AGENDA
CITY OF CREVE COEUR
PLANNING AND ZONING
300 NORTH NEW BALLAS RD
SEPTEMBER 5, 2023
6:00 PM

1. PUBLIC HEARING: Application #23-031: A Conditional Use Permit for a Warehouse/Storage Use Located at 1145 North Warson Road

2. PUBLIC HEARING: Applications #23-027 and #23-028: Applications for a Rezoning From "RO" Research Office District to the Olia Village "PMD" Planned Mixed-Use Development District with a Site Concept Plan and Phase One Site Development Plan with Associated Preliminary Plat for the 96 Acre former Bayer West Campus at 10300 Olive Boulevard

STREET PLAN

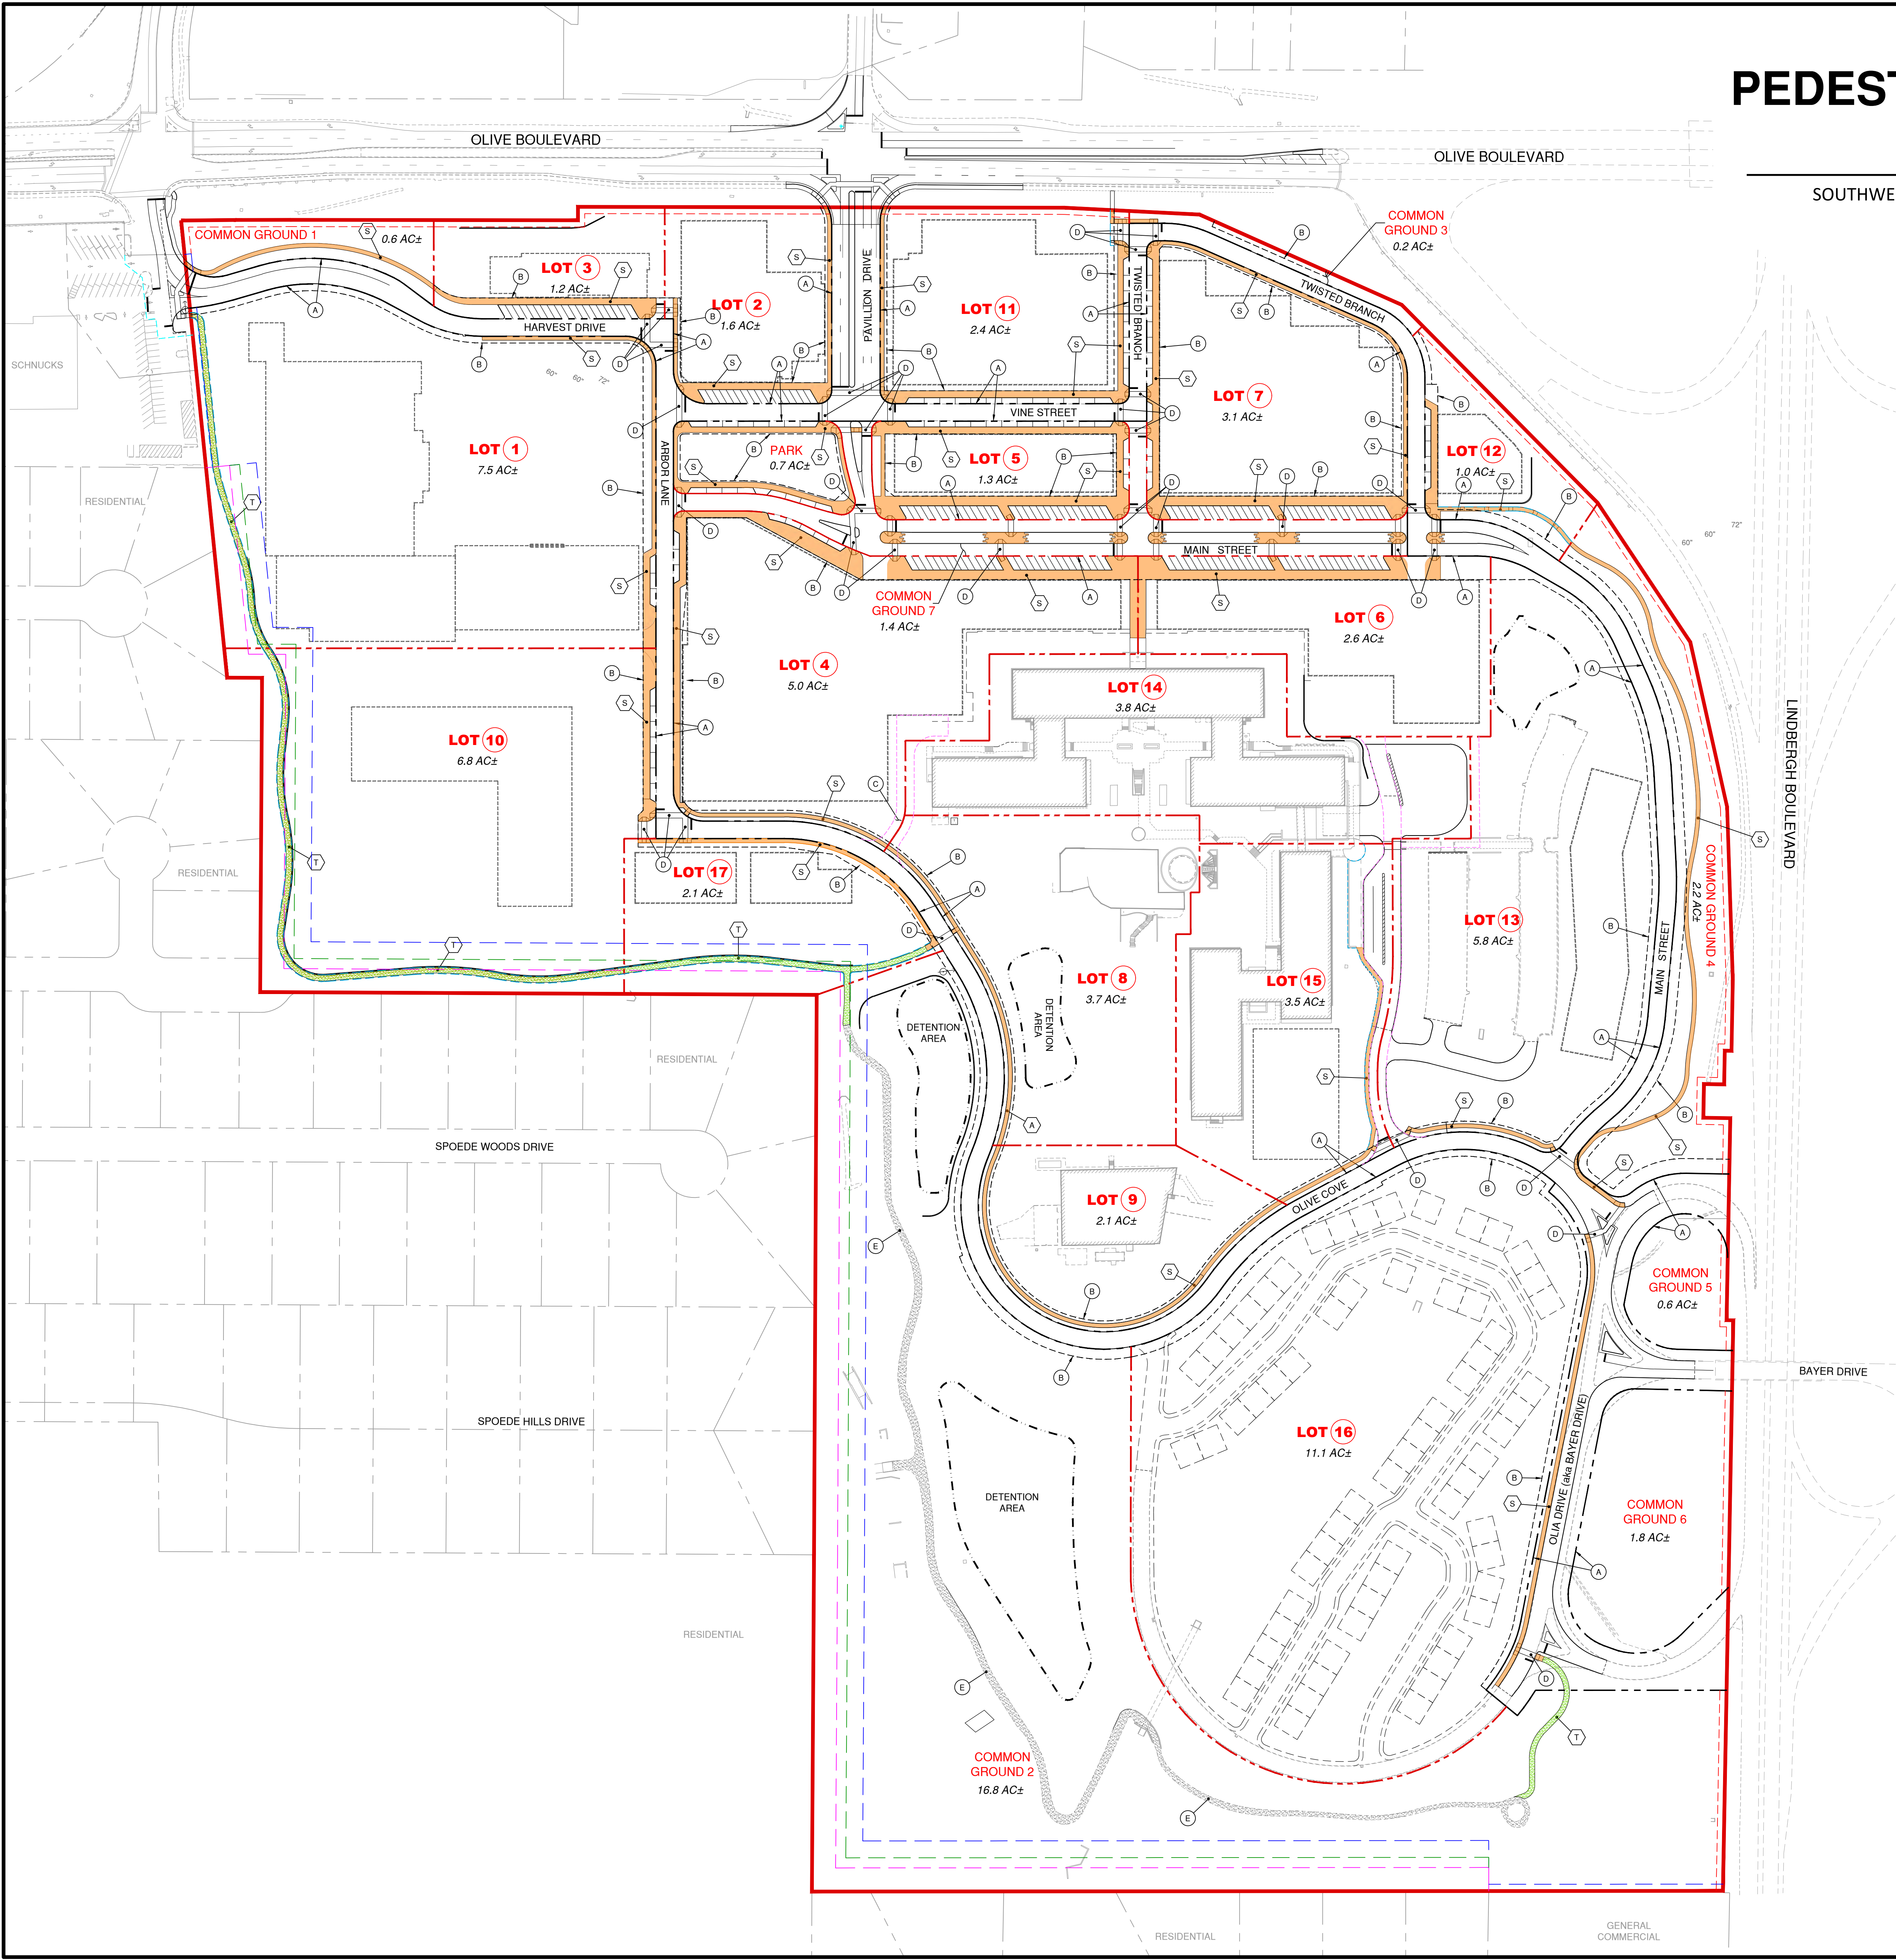
1. Site Concept Plan. Street Plan, Sheet C-107. In the response letter regarding the pedestrian crossing at the entrance to Olive Blvd. and across from Pavilion Drive, the developer seems agreeable to designing the improvements that would be constructed by others at a future date. We understand that a full crossing may not be feasible at this time due to lack of pedestrian facilities across Olive. However, this crossing has been identified as a priority in the comprehensive plan amendment and would also contribute to the Public Benefit requirements of the Planned Zoning District ordinance. City staff would request that all improvements be designed and constructed to the extent allowable by MoDOT in association with this development. City staff will be reaching out to MoDOT to discuss options regarding this crossing and will report back on this matter.

2. Site Concept Plan. Street Plan, Sheet C-107. City staff is agreeable to this revised plan to dedicate the streets to the City with the following comments:

Olia Team Response: Sheet C-107 has been updated to show "Future ROW" on the existing Schnuck's parcel to the west. Please note that the property in question is privately owned. The Olia Village development team is committed to working with the existing Schnuck's property landlord, when the time is right, to not only secure their approval of the changes, but also negotiate the additional ROW required between the current MoDOT ROW for Olive Boulevard and the proposed Olia Village ROW for Harvest Drive.

PEDESTRIAN PLAN

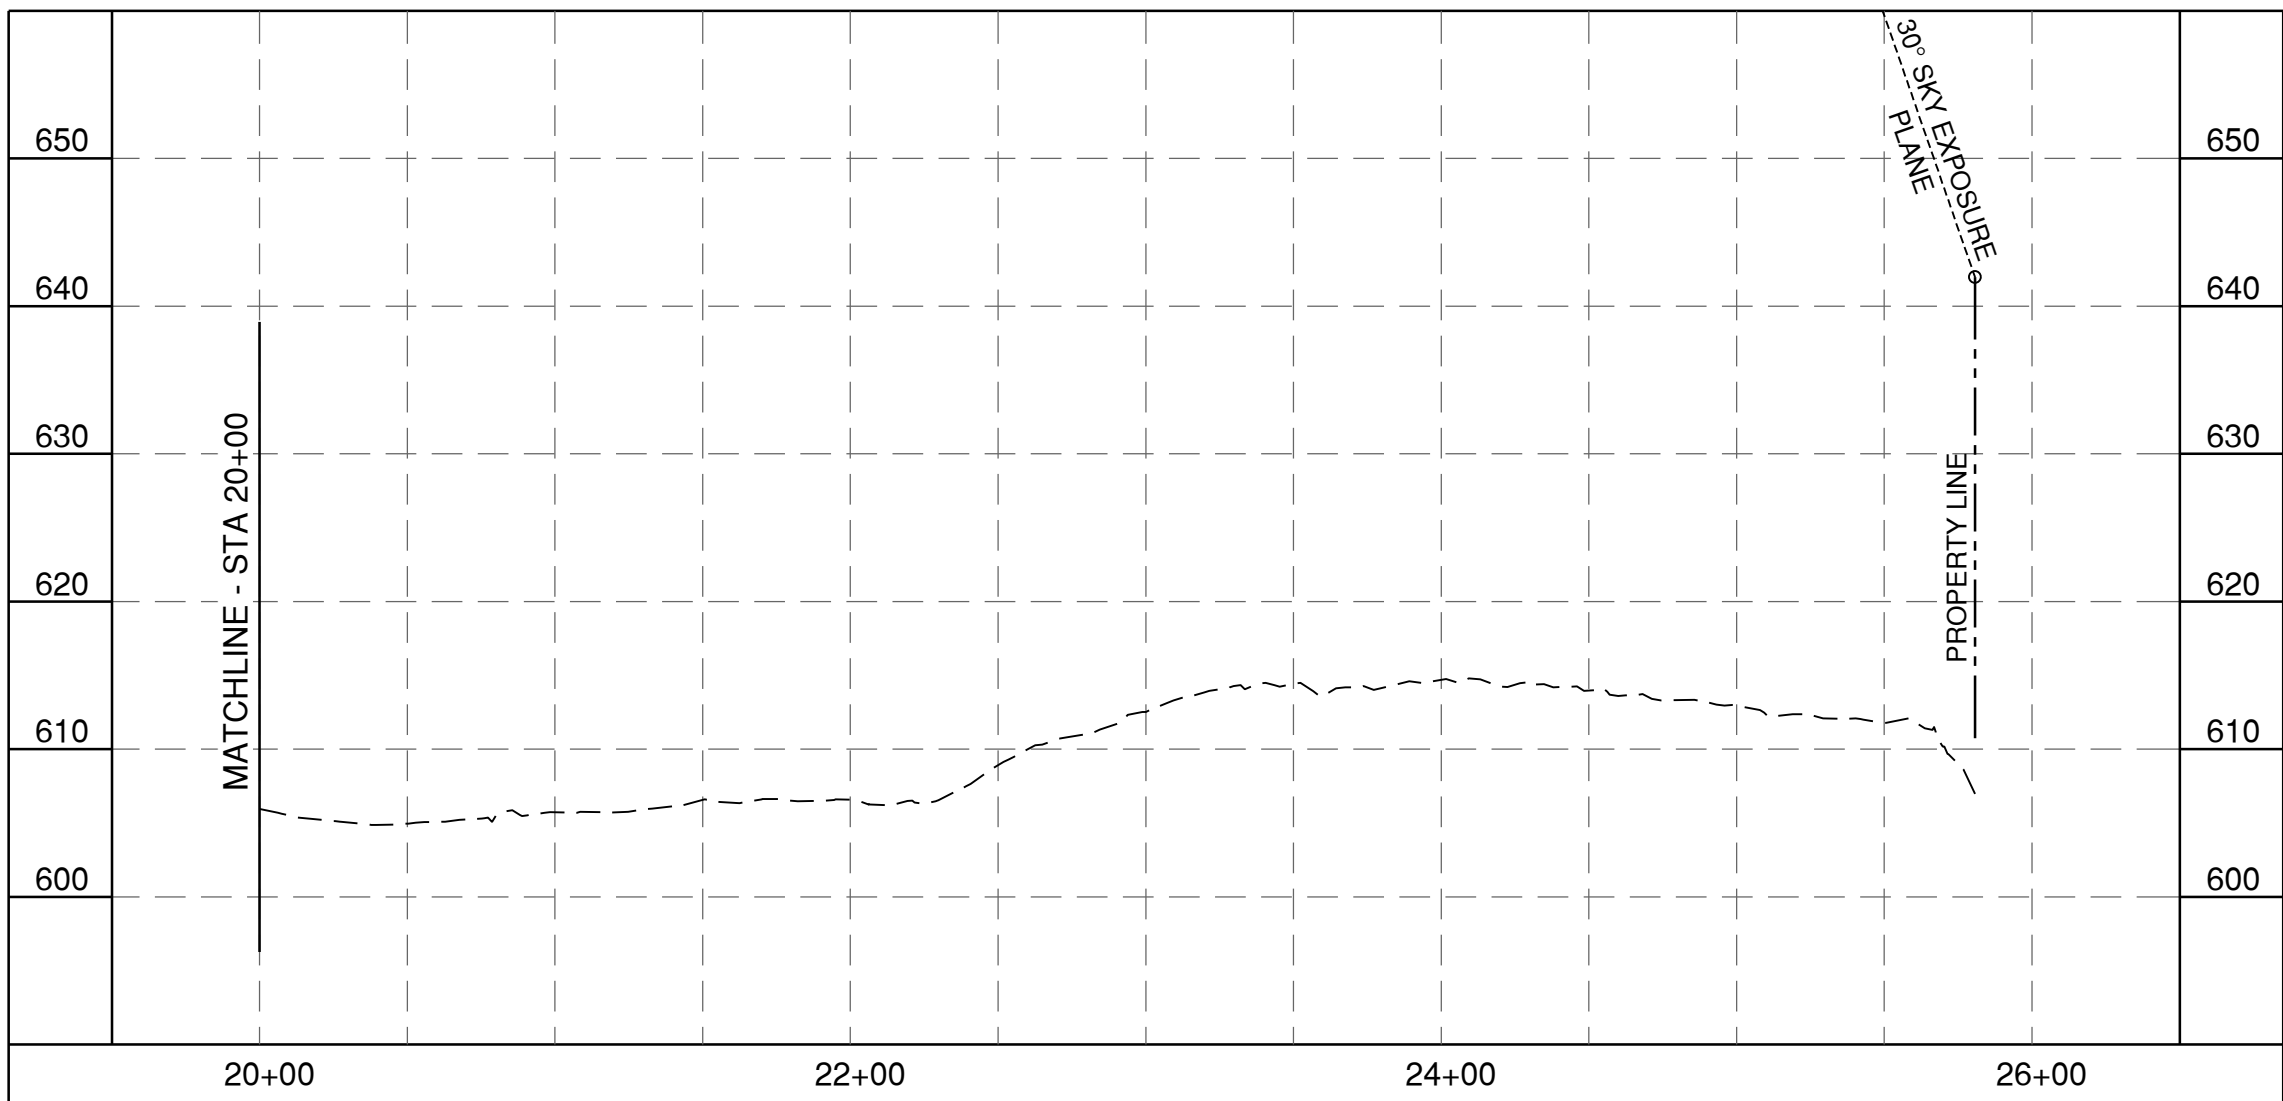
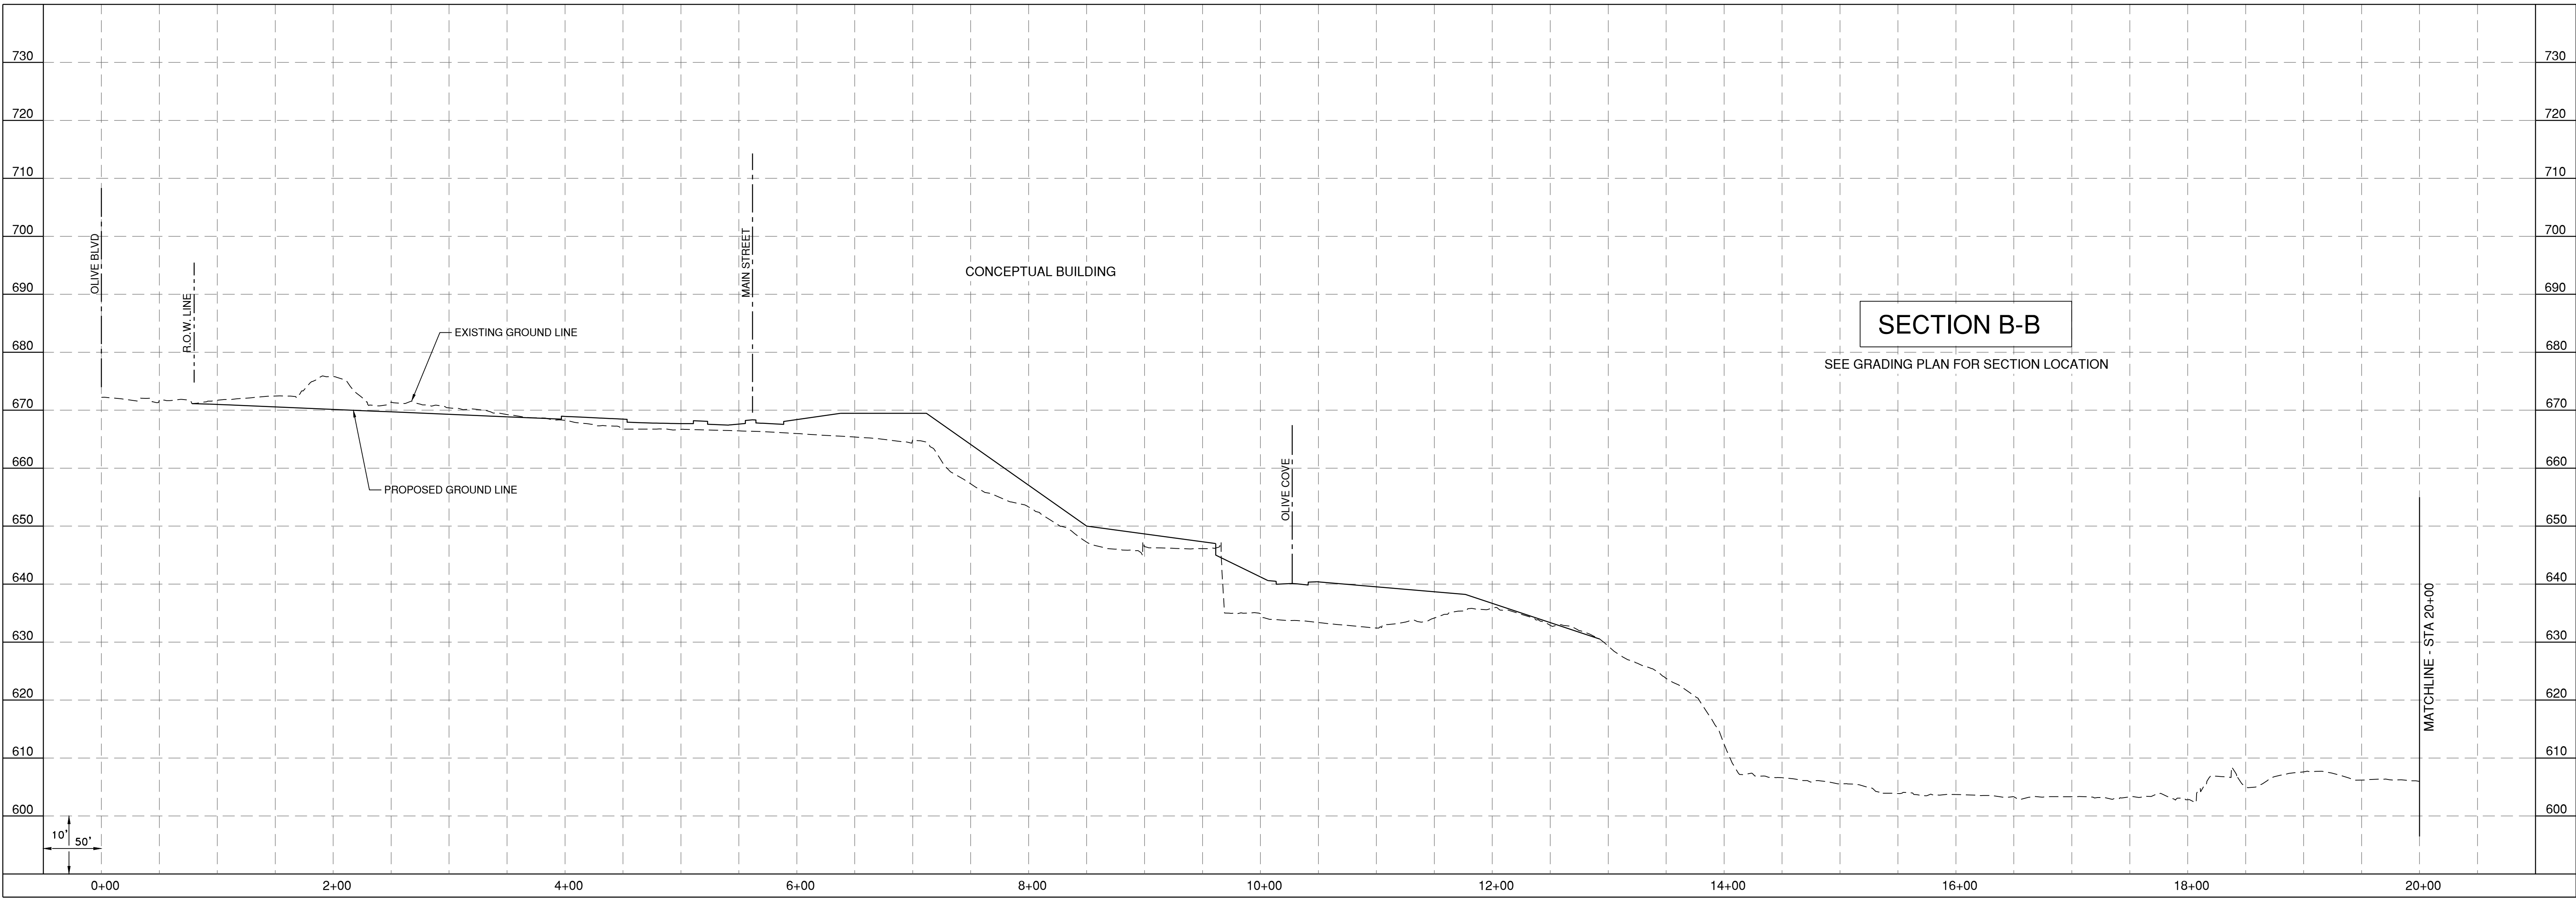
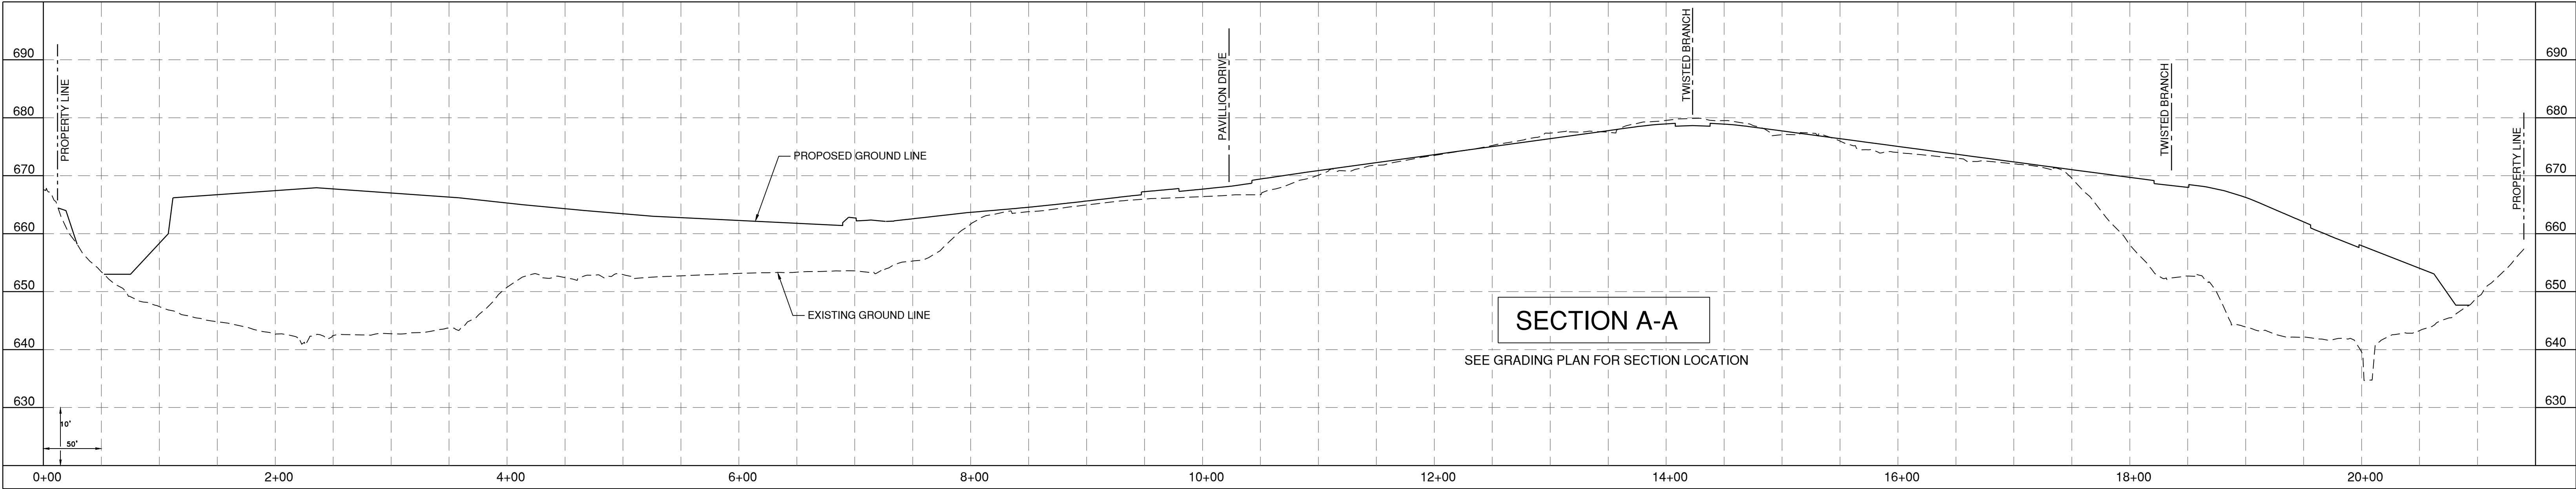
4. Site Concept Plan. Pedestrian Plan, Sheet C-108.
 - The revised plans seem to have eliminated the Shared Use Path design. Staff prefers a paved 8-foot wide Shared Use Path that would provide a continuous route throughout the development, connect the various components within the

Olia Team Response: Additional notes and details have been added to the SCP & SDP regarding the proposed pedestrian nature trail which includes anticipated widths and surface material for each section within the development. The portion of the trail / path which is to be constructed as part of Phase 1 is now shown on Sheet C-105 within the revised SDP set.
